Item 14: Ambrosden crossing - Quote:

TSRGD Diagram 1003.5

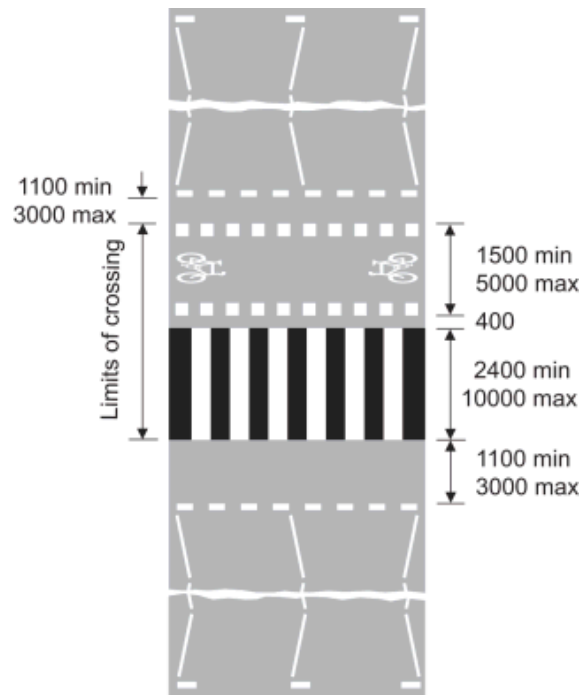
Finally, to pick up on Danny's point on colour, again from the Traffic Signs Manual Chapter 6:

Para. 17.2.4 .... Coloured surfacing may also be used to highlight the cycle route.

This *will* encourage journeys by cycling.
